Waitara Public School Redevelopment Modification 2

State Significant Development Modification Assessment
(SSD 8574 MOD 2)

September 2020

Figure 4 | Approved car parking layout (Source: Department's original consent 2019)

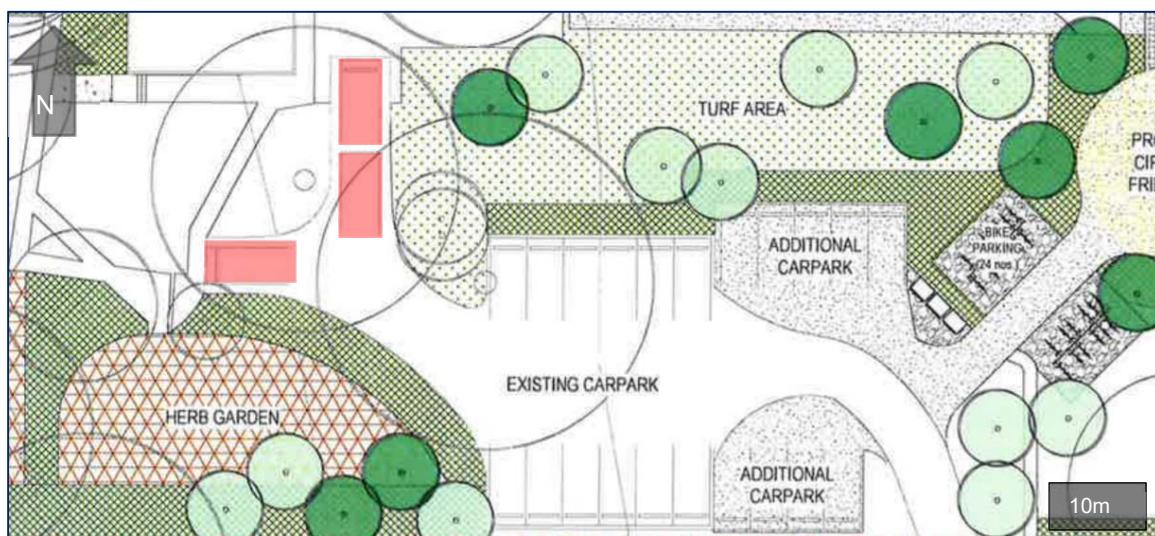
The Applicant advises that it has taken the opportunity to simplify the layout of the staff car park at the southern end of the school site. This includes the relocation of three car parking spaces originally to be located within a proposed service vehicle turning area (shown in red in **Figure 4**), to a new area proposed on the southern side of the car park (shown in red in **Figure 5**). The modification seeks to incorporate the amended plan into the plans listed under condition A2.

The approved development includes the provision of 24 on site car parking spaces, including three spaces in a service vehicle turning area. These are subject to restrictions on hours of use to times outside of service vehicle delivery hours. The proposed modification seeks to relocate the three car parking spaces from the turning area to the southern side of the car parking area (**Figure 4** and **Figure 5**). To accommodate the new car parking arrangement, conditions A2, D10 and D11, relating to the approved plans, OTAMP and car parking arrangements respectively, are proposed to be modified.

As part of the modification application, the Applicant submitted a design verification statement that confirmed that the location of the new car parking spaces complies with the requirements of the Building Code of Australia and relevant Australian Standards. The statement acknowledged that the car parking arrangement has been designed in accordance with the AS2890.1:2004 – 'Parking facilities' – Part 1: Off street car parking and is consistent with the requirements of condition B37 Car Parking and Service Vehicle Layout.

The Department has reviewed the information provided by the Applicant and considers that the modification is appropriate as it would free up the turning area for unrestricted use by delivery and service vehicles and retain the approved on site car parking rate. In addition, it would not result in additional tree removal, would not decrease the number of trees or student play areas to be provided on site.

Overall, the Department considers the modification would result in improvements to the operational car parking and access arrangements. Consequently, the Department accepts the proposed modifications to conditions A2, D10 and D11 to accommodate the new layout. The Department has recommended amended conditions accordingly.

Figure 7 | Proposed landscape plan (Source: Applicant's modification application 2020)

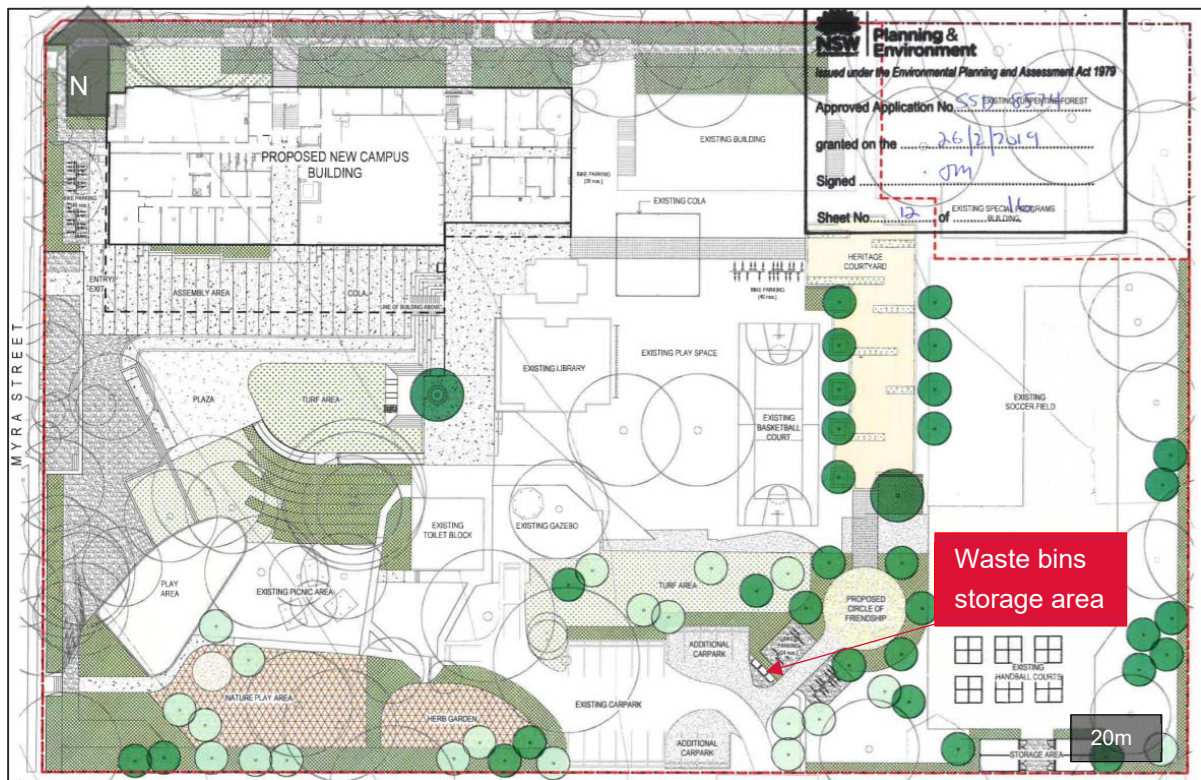
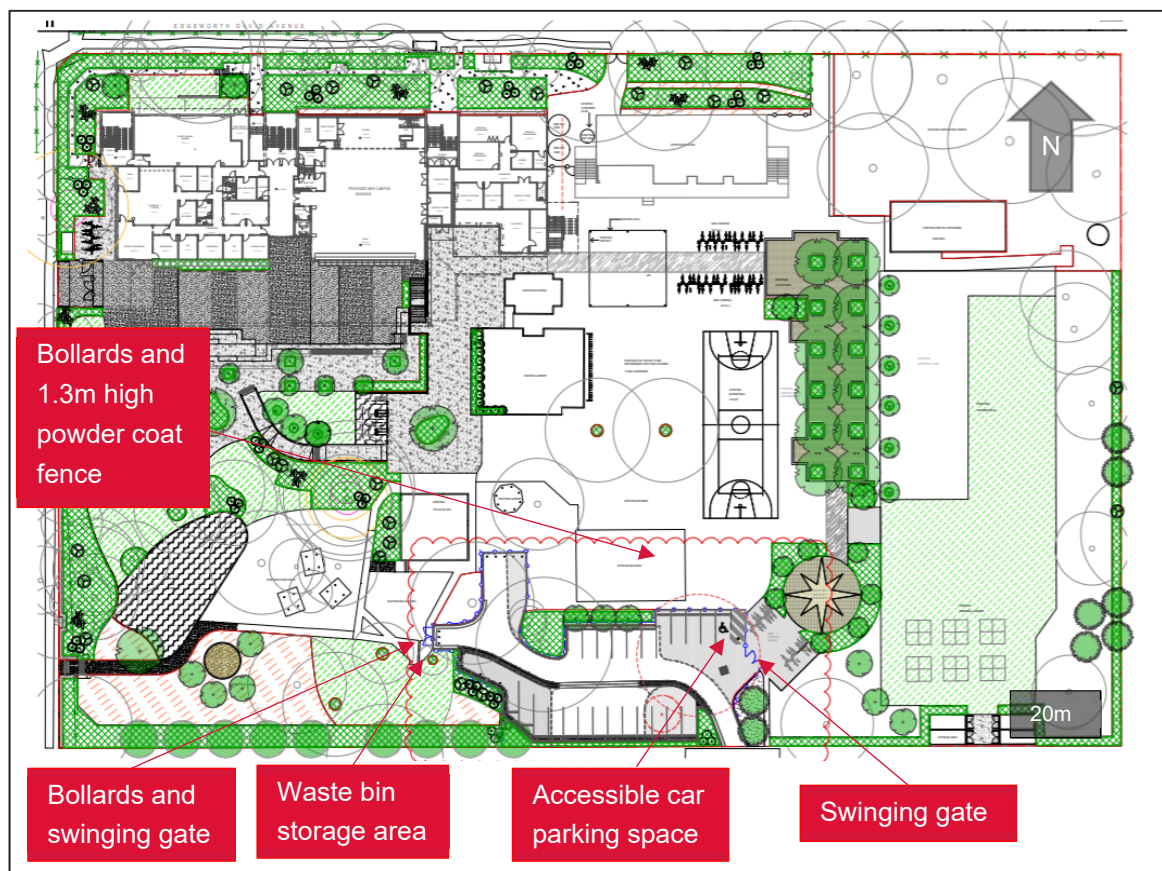
- reflect the changed car parking layout and include new bollards and a 1.3 metre high powder coated fence, with swinging gates, to separate the car park and turning area from the surrounding open space and bicycle parking area.
- generally update the layout following detailed design work.
- increase tree planting on site from 52 to 135.
- relocate a waste storage area.

A comparison of the approved and proposed landscape plan are shown in **Figure 6** and **Figure 7**. The modification seeks to incorporate the amended plans into the plans listed under condition A2.

The Department notes that the proposed changes to landscaping would significantly increase the number of trees to be planted on site and provide improved physical separation between the carpark and surrounding outdoor play areas.

The Department considers that the proposed changes would maintain varied landscape treatments across the site for student play and learning and continue to maintain the landscape character of the site. Overall, the Department is satisfied that the proposed changes are appropriate and accepts the proposed modifications to condition A2.

Figure 9 | Proposed play area - 12, 652 square metres (Source: Applicant's modification application 2020)

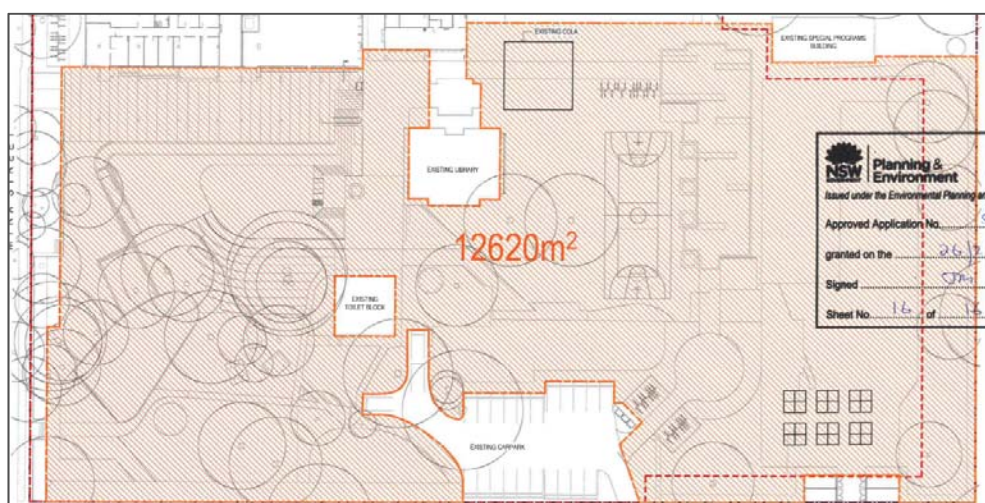
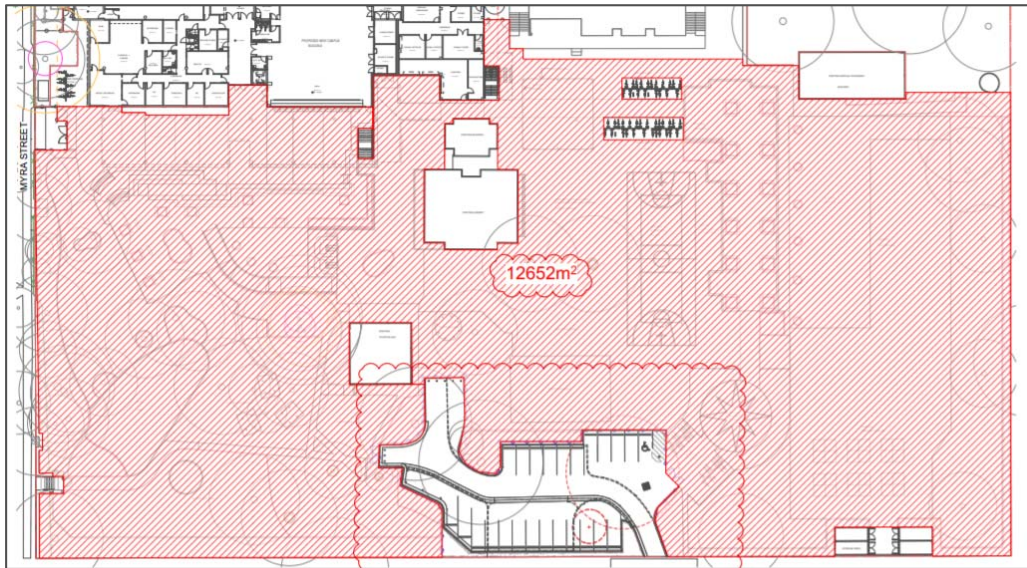
The Applicant also advised that whilst the modification involves an increase to the footprint of the car parking area, the overall student play area on site would not decrease (**Figure 8** and **Figure 9**).
